**TENDER FOR RE-CONSTRUCTION OF NORTH JETTY AT NAVAL BASE, KOCHI ON  
ENGINEERING, PROCUREMENT AND CONSTRUCTION CONTRACT BASIS**

(T10/T-1910/2020-C)

**ADDENDUM / CORRIGENDUM NO.7**

DRAWING NUMBER: **60614746-DWG-TD-0000-PL-4005** REV. **2**

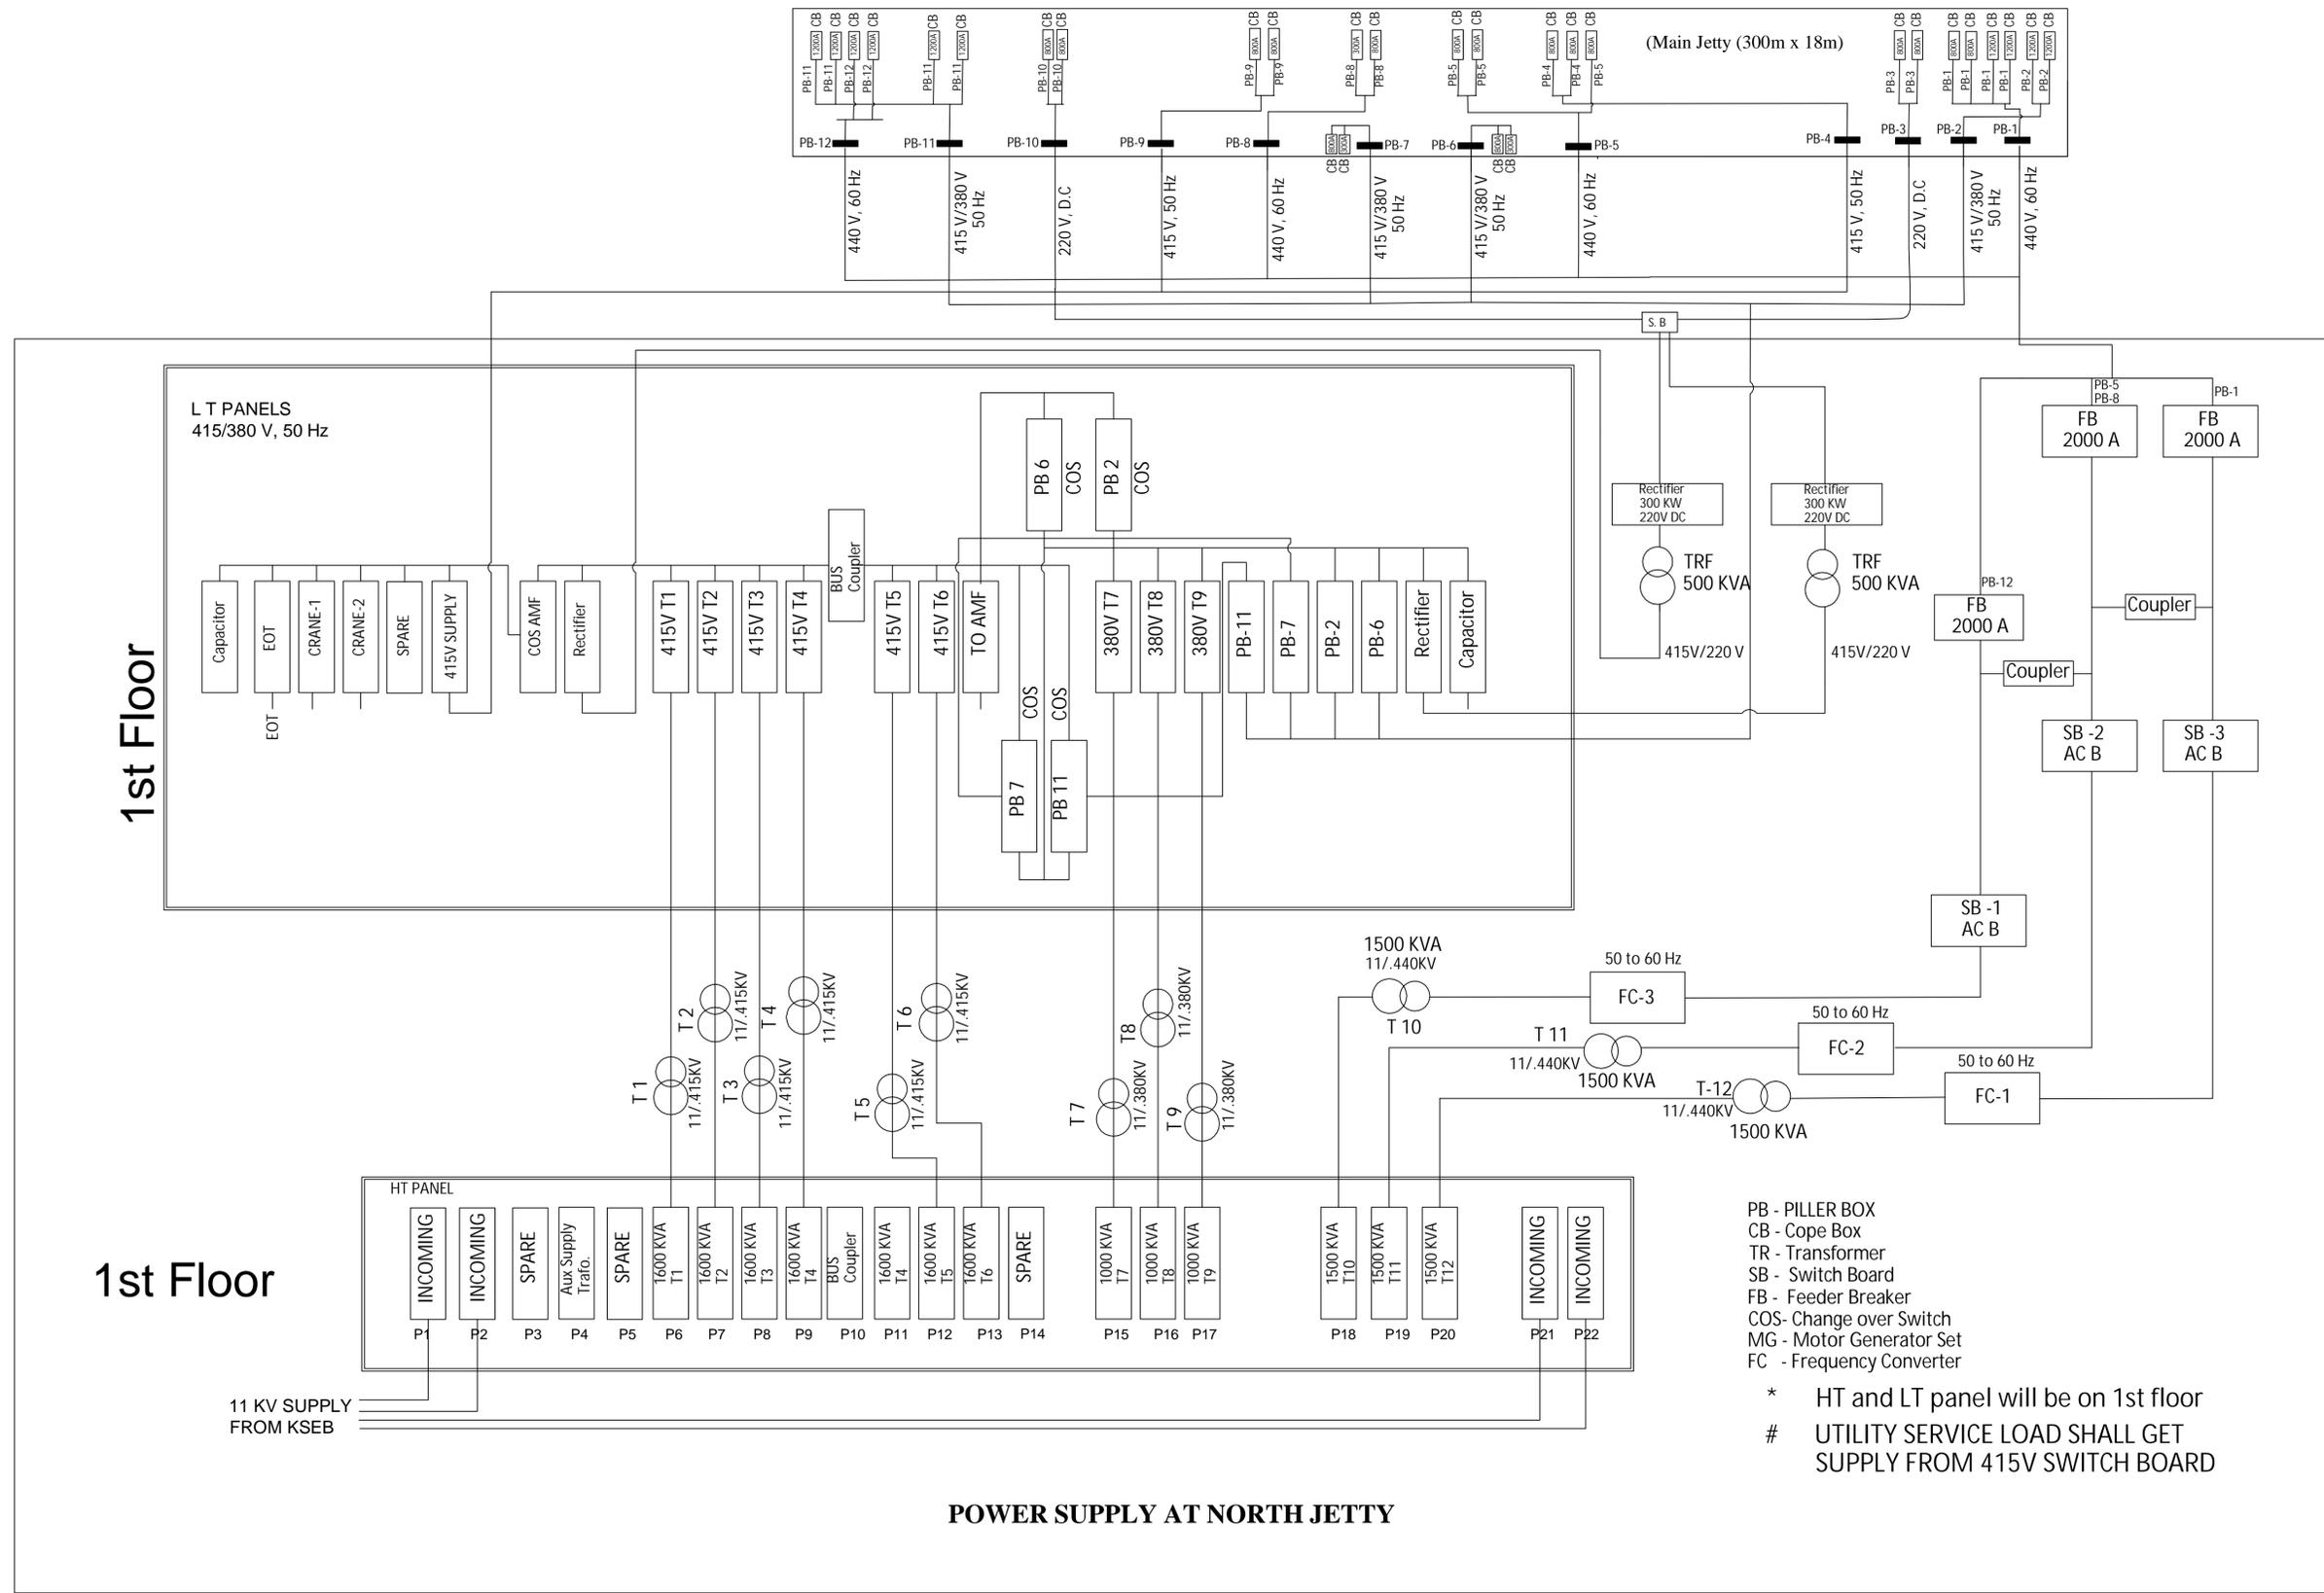
S. No.	Particulars	14	Low Pressure compressors	21	Hammerhead Cranes (50 T capacity)
S. No.	Particulars								
14	Low Pressure compressors								
21	Hammerhead Cranes (50 T capacity)								
29.	Sl.No.33 of Addendum No.5, Clause 7B.3.16.15	Addendum No.5, Section-7B, Volume II	<p><b><u>Replace fourth para under clause 7B.3.16.15 with the following:</u></b></p> <p>Panels made up of special material called "Aluminium Zinc". The painting to be done as per manufacturer standards.</p>						
30.	Clause 7B.3.16.27	Section-7B, Volume II	<p><b><u>Modify the last para in the clause 7B.3.16.27 with the following:</u></b></p> <p>DG set shall feed supply to the Lighting system in the Building &amp; outdoor, Crane, ELV equipment, Control Room, Fire Pumps, Ventilation system, UPS system etc. during primary source failure.</p>						
31.	Drawings	Section-7C, Volume II	<p><b><u>Replace Drawings 60614746-DWG-TD-0000-PL-4005, Rev.1 and 60614746-DWG-TD-0000-PL-4007</u></b> with following Drawings</p> <p><b><u>60614746-DWG-TD-0000-PL-4005, Rev.2 and 60614746-DWG-TD-0000-PL-4007, Rev.1.</u></b></p>
